Re: **Goldwell Neighborhood (18-14-S) – Berkshire Township – 119 lots / 44.9 acres**

Site Review Comments
Drainage Maintenance & DESC Permit

Northstar Goldwell Neighborhood

General Comments for Preliminary Subdivision Review

Figure 1

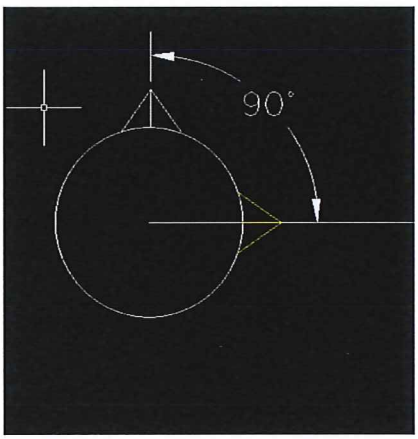
1. Goldwell Drive has an eyebrow. Road Structures with Eyebrows are not permitted as per Article VI, Section 601, Part C2jj. Provide an alternate design.
2. The Centerline radius of Goldwell Drive at the eyebrow is only 178-feet where 250 is required for level terrain. Please, provide an alternate design.
3. The main entrance street (Goldwell Drive) is located on the inside of the apex of a horizontal curve with mounding looking right (west) for departing traffic. Please, ensure the intersection has proper sight distance with respect to the mounding. In addition determine if the angle of sight is such that it does not exceed 90^0 from the forward position.
